**Source:** TSG CT WG4  
**Title:** Corrections on Camel4  
**Agenda item:** 8.3  
**Document for:** APPROVAL

⌘ **23.078 CR 772** ⌘ rev - ⌘ Current version: **6.5.0** ⌘

<b>Title:</b>	⌘ Correction to No_Answer handling in CAMEL_ICA_MSC2		
<b>Source:</b>	⌘ Ericsson		
<b>Work item code:</b>	⌘ Camel4	<b>Date:</b>	⌘ 27 April 2005
<b>Category:</b>	⌘ <b>A</b>	<b>Release:</b>	⌘ Rel-6
<i>Use one of the following categories:</i>		<i>Use one of the following releases:</i>	
<b>F</b> (correction)		<b>Ph2</b> (GSM Phase 2)	
<b>A</b> (corresponds to a correction in an earlier release)		<b>R96</b> (Release 1996)	
<b>B</b> (addition of feature),		<b>R97</b> (Release 1997)	
<b>C</b> (functional modification of feature)		<b>R98</b> (Release 1998)	
<b>D</b> (editorial modification)		<b>R99</b> (Release 1999)	
		<b>Rel-4</b> (Release 4)	
		<b>Rel-5</b> (Release 5)	
		<b>Rel-6</b> (Release 6)	
		<b>Rel-7</b> (Release 7)

Figure 4.11-2: Procedure CAMEL\_MO\_Dialled\_Services (sheet 2)

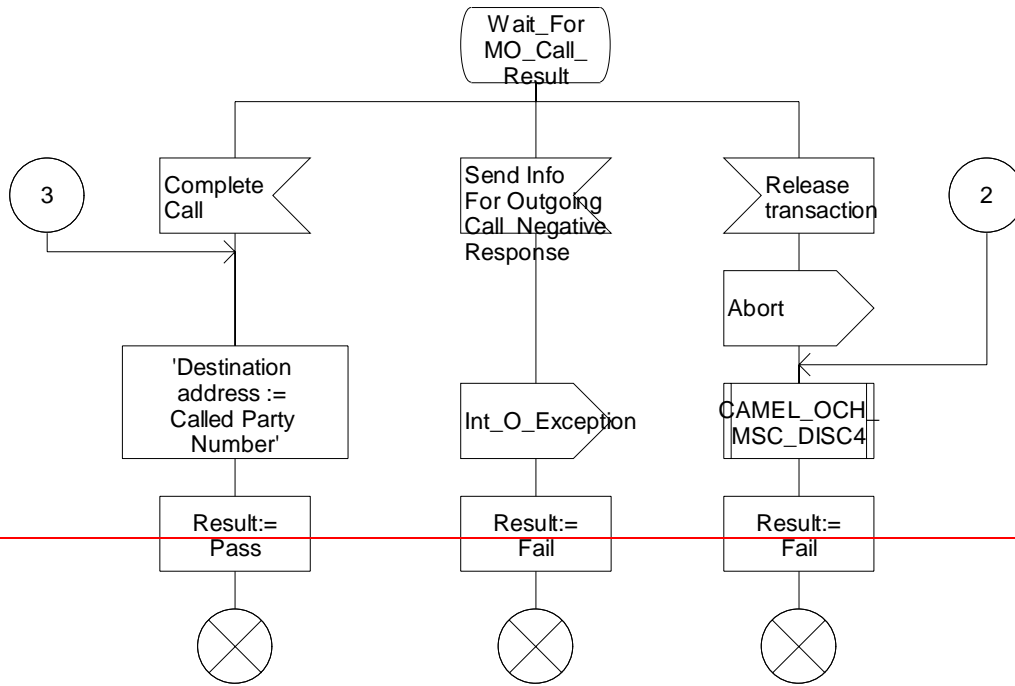
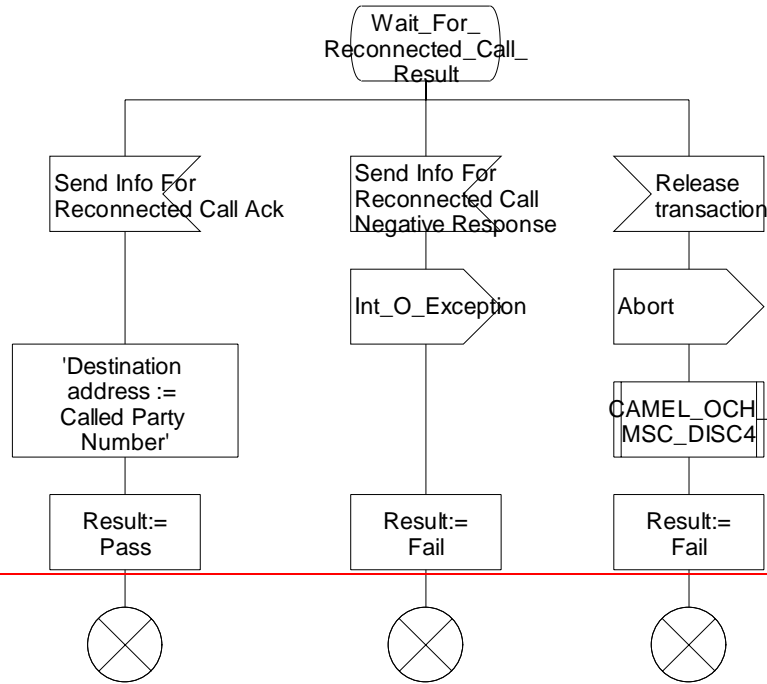
<b>Reason for change:</b>	⌘ THIS IS AN ESSENTIAL CORRECTION
	In sheet2 and 3 of procedure CAMEL_MO_Dialled_Services, on the upper right box, is mentioned that "...signals to/from the right are to/from the VLR". This is not true for signals "Int_O_Exception" because these signals are actually sent to the gsmSSF.
<b>Summary of change:</b>	⌘ A dotted line is added to indicate the correct receiver of the signal.
<b>Consequences if not approved:</b>	⌘ Signals "Int_O_Exception" sent to a wrong node causing misbehaviour/malfunction of CAMEL MO Dialled Services.

Figure 4.11-2: Procedure CAMEL\_MO\_Dialled\_Services (sheet 2)

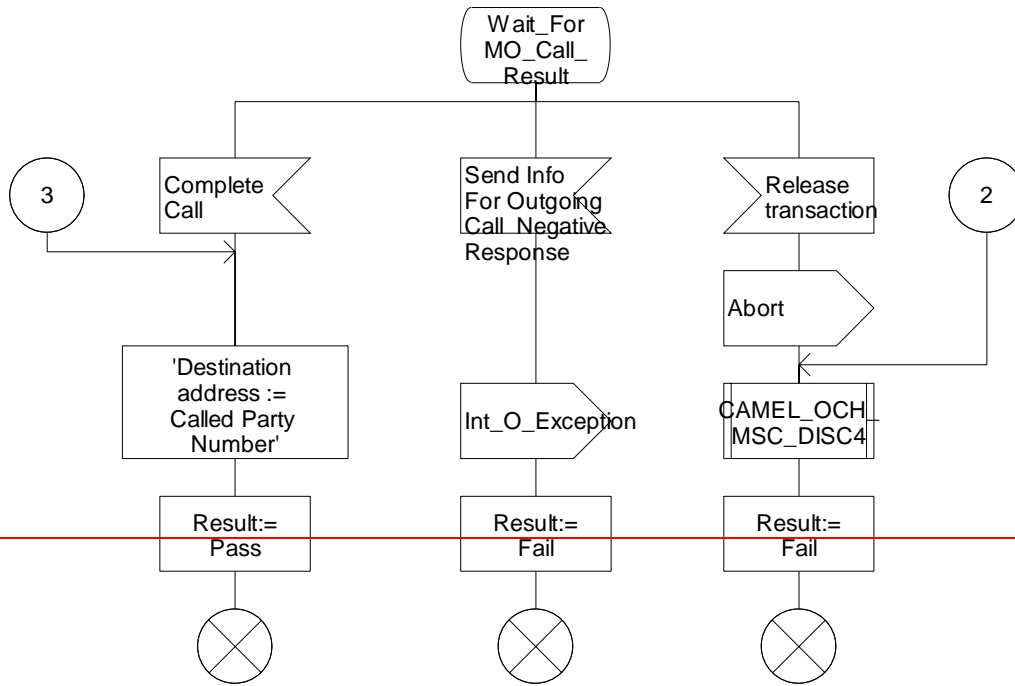
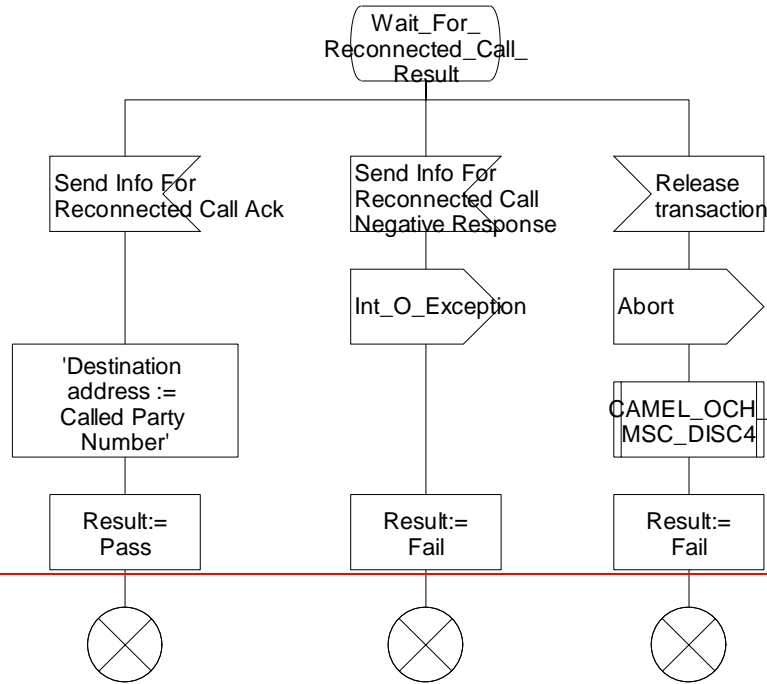
<b>Reason for change:</b>	⌘ <b>THIS IS AN ESSENTIAL CORRECTION</b>
	In sheet2 and 3 of procedure CAMEL_MO_Dialled_Services, on the upper right box, is mentioned that "...signals to/from the right are to/from the VLR". This is not true for signals "Int_O_Exception" because these signals are actually sent to the gsmSSF.
<b>Summary of change:</b>	⌘ A dotted line is added to indicate the correct receiver of the signal.
<b>Consequences if not approved:</b>	⌘ Signals "Int_O_Exception" sent to a wrong node causing misbehaviour/malfunction of CAMEL MO Dialled Services.

Figure 4.90-1: Procedure CAMEL\_ICA\_MSC2 (sheet 1)

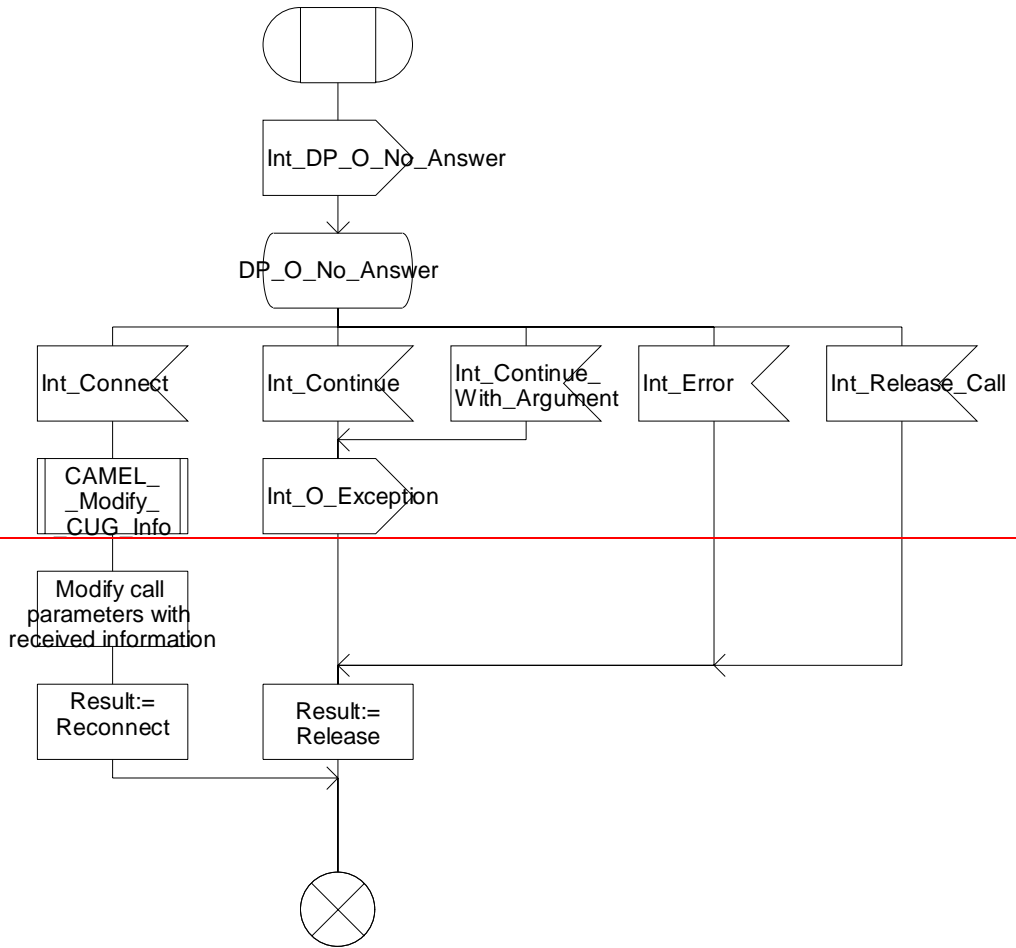
**Reason for change:** ⌘ **THIS IS AN ESSENTIAL CORRECTION**  
Procedure CAMEL\_ICA\_MSC2 in section 4.5.6 (Handling of gsmSCF initiated calls) contains a superfluous Int\_O\_Exception signal.

There is no rationale for sending this Int\_O\_Exception after reporting a No Answer condition for an ICA leg (Procedure CAMEL\_ICA\_MSC2).

Hence, the Int\_O\_Exception signal from Procedure CAMEL\_ICA\_MSC2 should be removed. This is especially true since the gsmSSF process that is controlling the ICA leg for which the No Answer event occurs, may be controlling other ICA legs as well (an ICA leg may be moved to Call Segment 1 from Alerting onwards). Hence, when No Answer event occurs on one ICA leg and the gsmSCF responds with CAP Continue on the EDP-R event for that leg, then the gsmSSF process may remain active for the purpose of controlling the other legs

in Call Segment 1.									
<b>Summary of change:</b>	⌘	Correct figure <b>Error! Reference source not found.</b> 1-1: Procedure CAMEL_ICA_MSC2 (sheet 1) as described above.									
<b>Consequences if not approved:</b>	⌘	The gsmSSF will receive an erroneous exception signal, leading to premature call termination or unexpected behaviour.									
<b>Clauses affected:</b>	⌘	4.5.6									
<b>Other specs affected:</b>	⌘

Figure 4.87-1: Procedure CAMEL\_ICA\_MSC\_ALERTING (sheet 1)

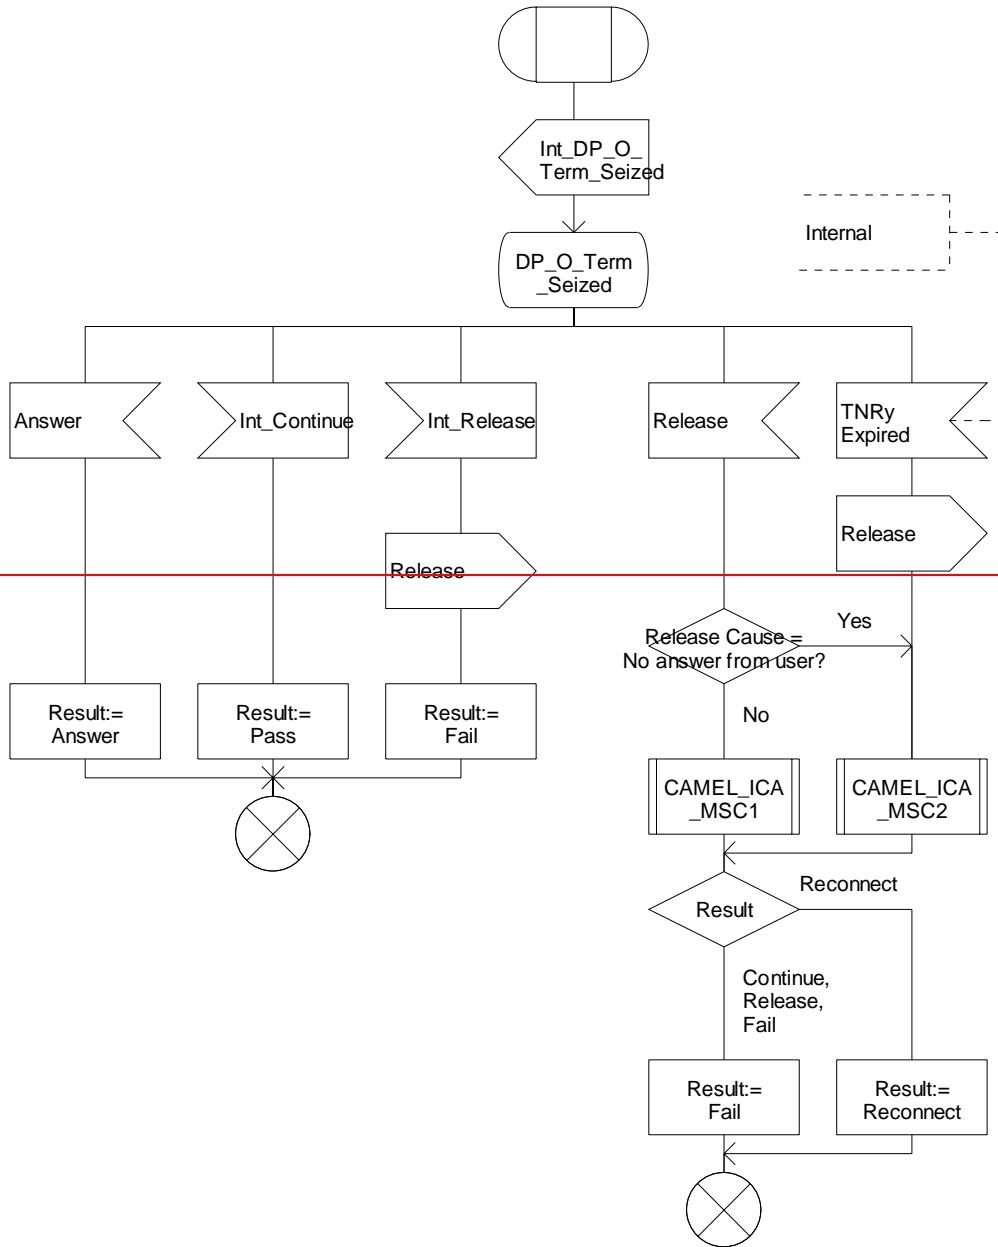
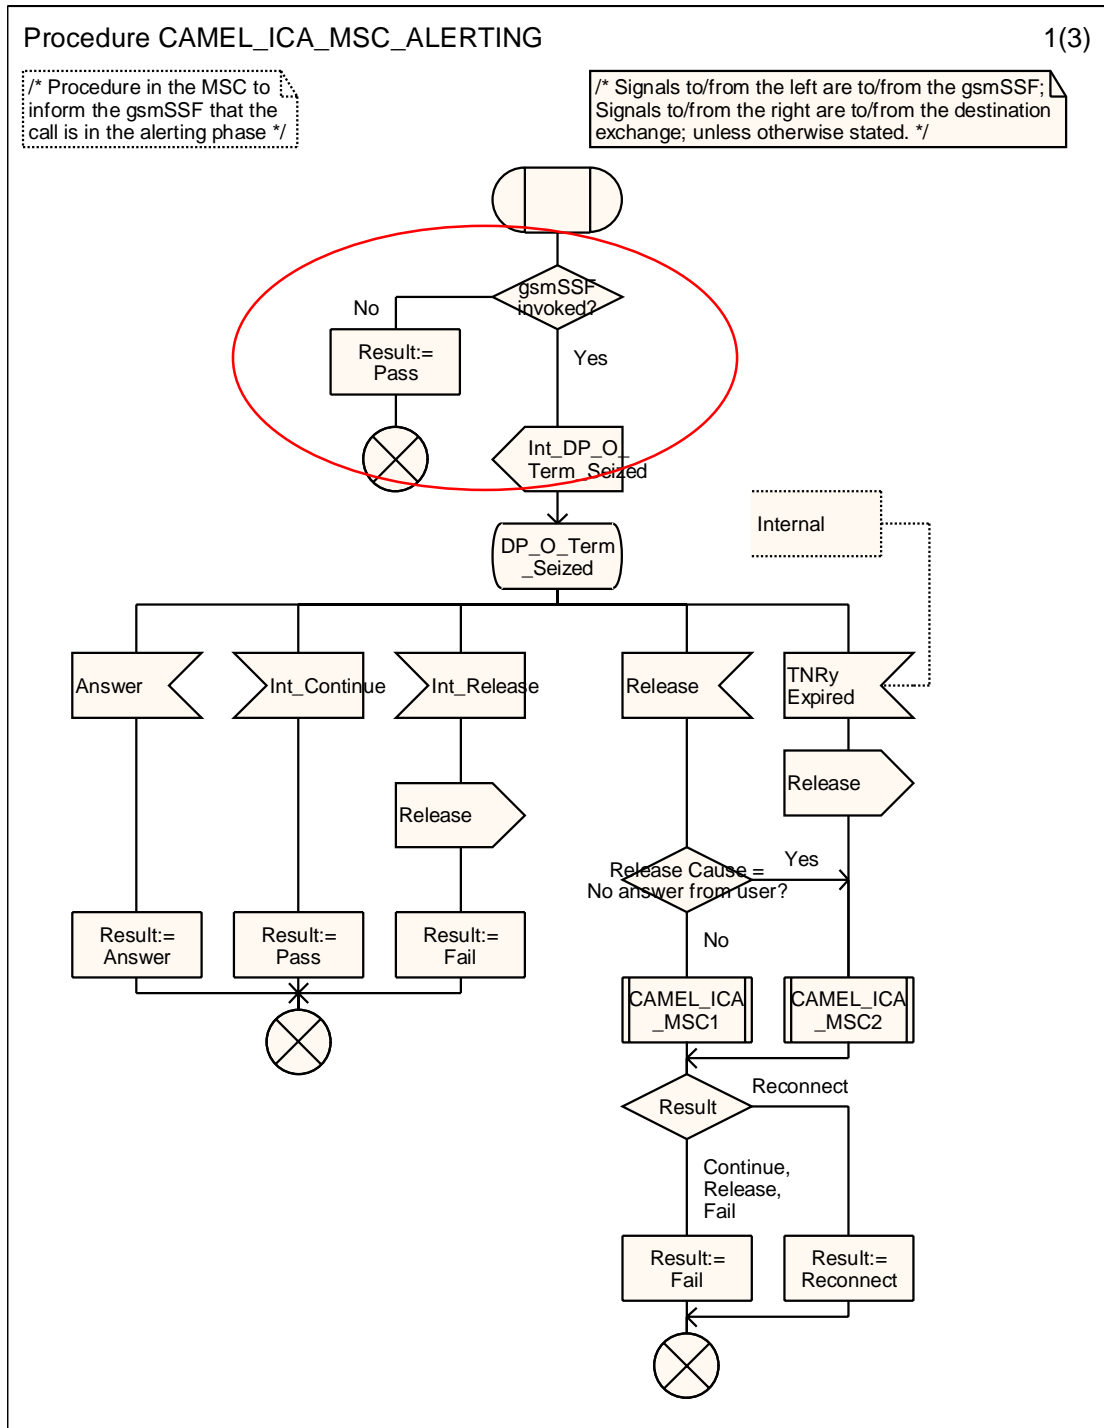
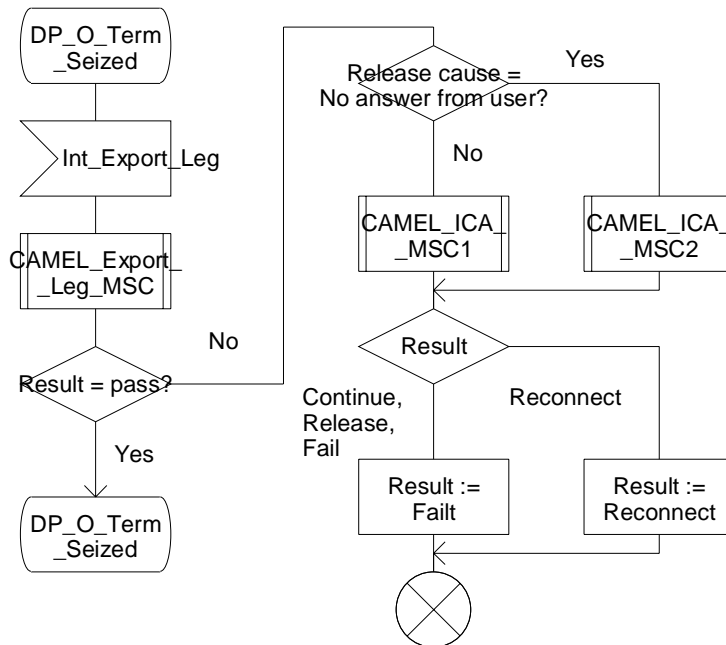
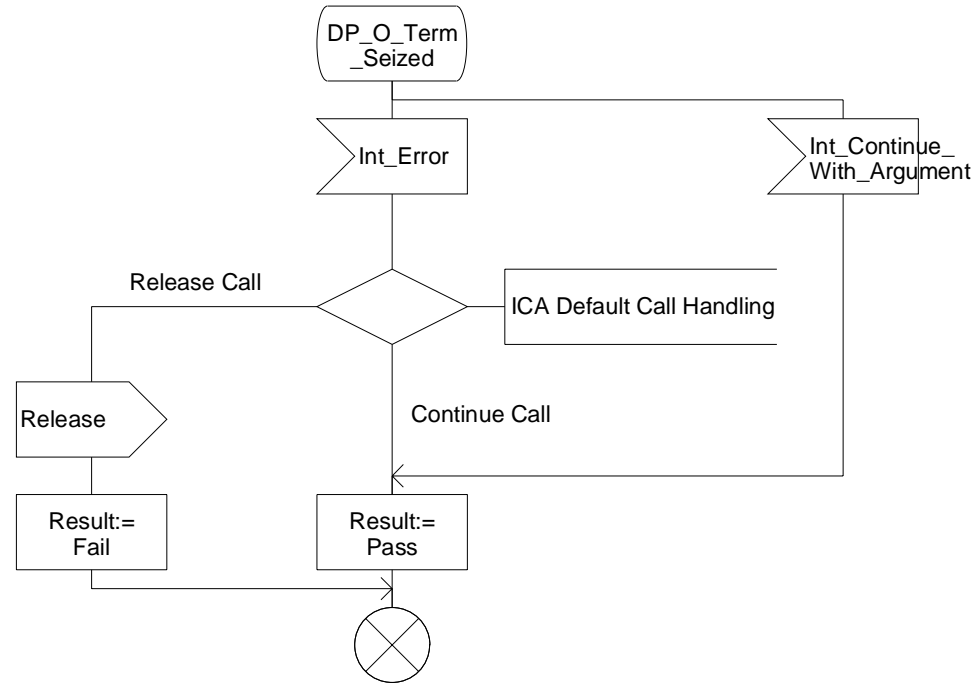
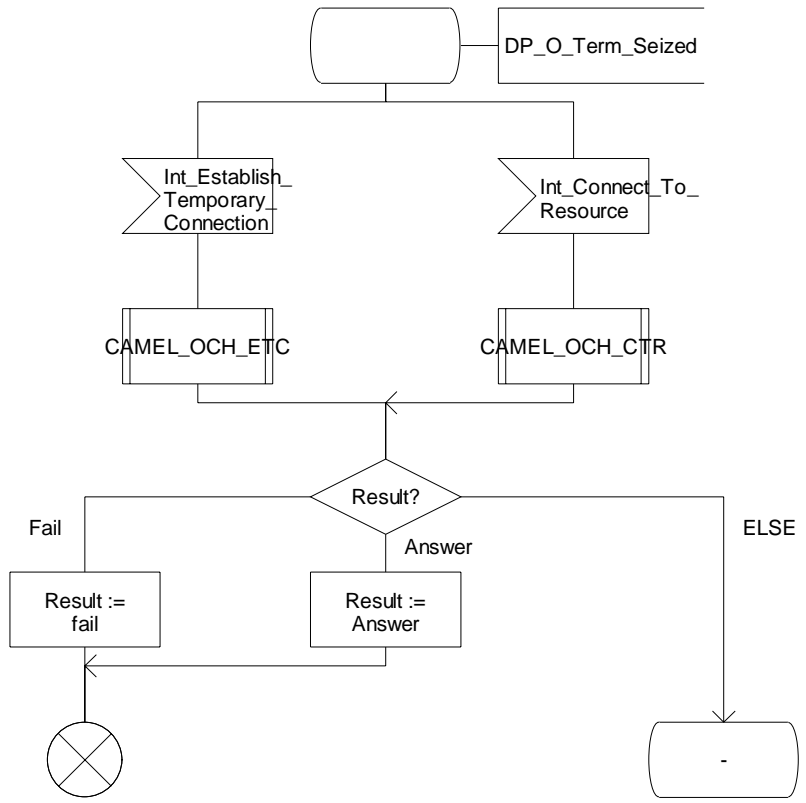
The procedures CAMEL\_ICA\_MSC\_ANSWER, CAMEL\_ICA\_MSC\_ALERTING, CAMEL\_ICA\_MSC1 and CAMEL\_ICA\_MSC2 in section 4.5.6 (Handling of gsmSCF initiated calls) need correction.

<p>CAMEL_ICA_MSC2 would actually need this check “<i>gsmSSF invoked?</i>”.</p> <p>For the same reason, the procedures CAMEL_ICA_MSC_ANSWER, CAMEL_ICA_MSC_ALERTING need the check “<i>gsmSSF invoked?</i>”.</p> <p>When Disconnect occurs on an ICA leg, then procedure CAMEL_OCH_MSC_DISC2 is called. That procedure is specified in section 4.5.2 (Handling of mobile originated calls) and contains already the check for an active gsmSSF process.</p>
<b>Summary of change:</b> ⌘	Add the check <i>check “gsmSSF invoked?”</i> to CAMEL_ICA_MSC_ANSWER, CAMEL_ICA_MSC_ALERTING, CAMEL_ICA_MSC1 and CAMEL_ICA_MSC2 in section 4.5.6 (Handling of gsmSCF initiated calls).
<b>Consequences if not approved:</b> ⌘	Unnecessary signal is sent to the gsmSSF process that may not actually exist. Implementers may expect that call events like Busy, Answer etc. can always be reported to the SCP, which would cause unexpected behaviour.
